McCULLOCH CORPORATION
SERVICE BULLETIN

1481

MODEL: 940 October 17, 1969

SUBJECT: FIXED HIGH SPEED JET CARBURETOR

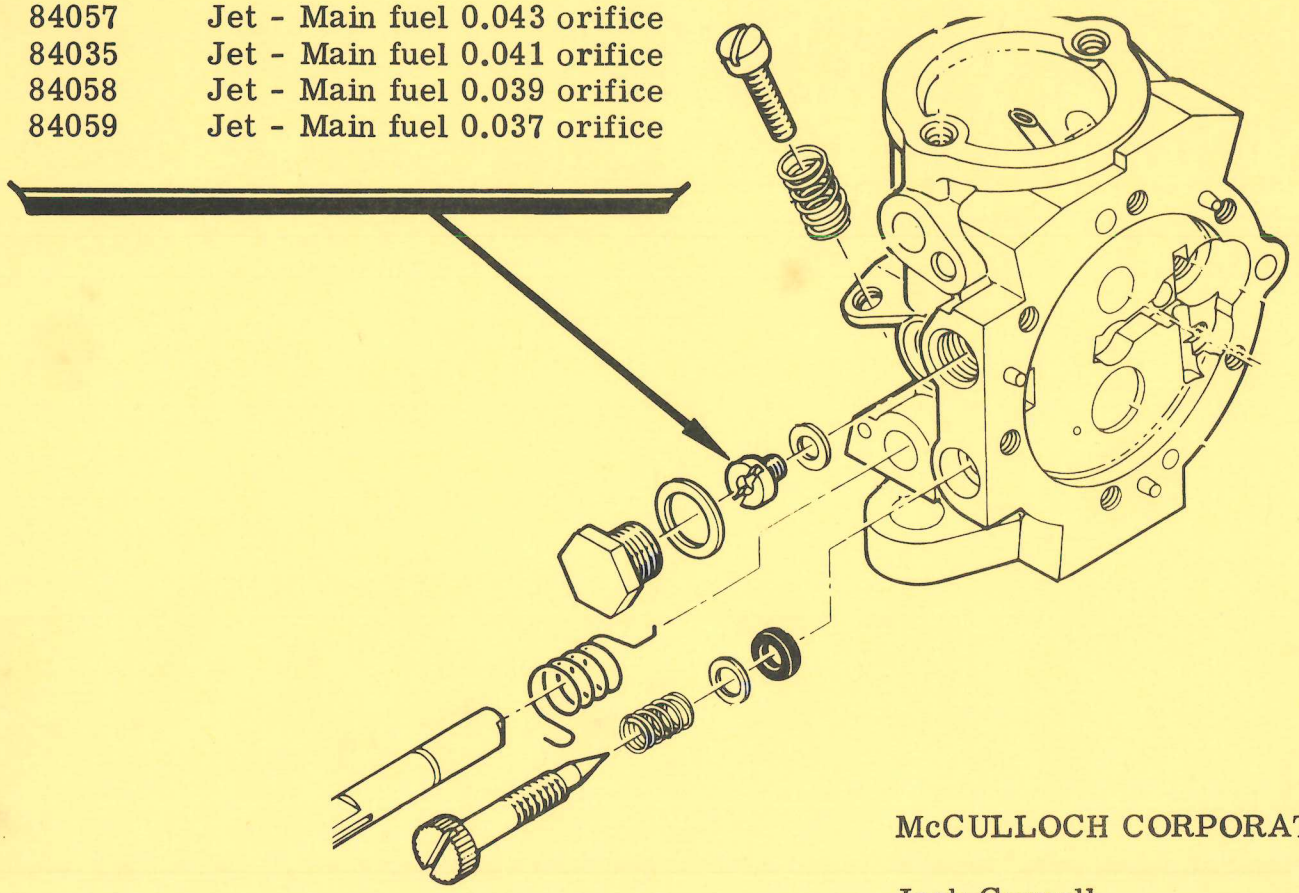
Carburetors used on Model 940 saws with serial numbers prefixed 11- have a fixed high speed jet. The standard jet supplied with the carburetor has an orifice of 0.041 inch diameter.

Alternate jets of 0.043, 0.039 and 0.037 inch diameters are available. Use the next smaller orifice if the high speed fuel mixture is too rich. Use the next larger orifice if the high speed fuel mixture is too lean.

Ordinarily the 0.041 and 0.039 inch orifices will cover the general broad range of cutting conditions. Do not use the 0.037 inch orifice below 4000 feet altitude. Use the 0.043 inch orifice only if an extremely rich mixture is desired.

Part No.	Description
84057	Jet - Main fuel 0.043 orifice
84035	Jet - Main fuel 0.041 orifice
84058	Jet - Main fuel 0.039 orifice
84059	Jet - Main fuel 0.037 orifice
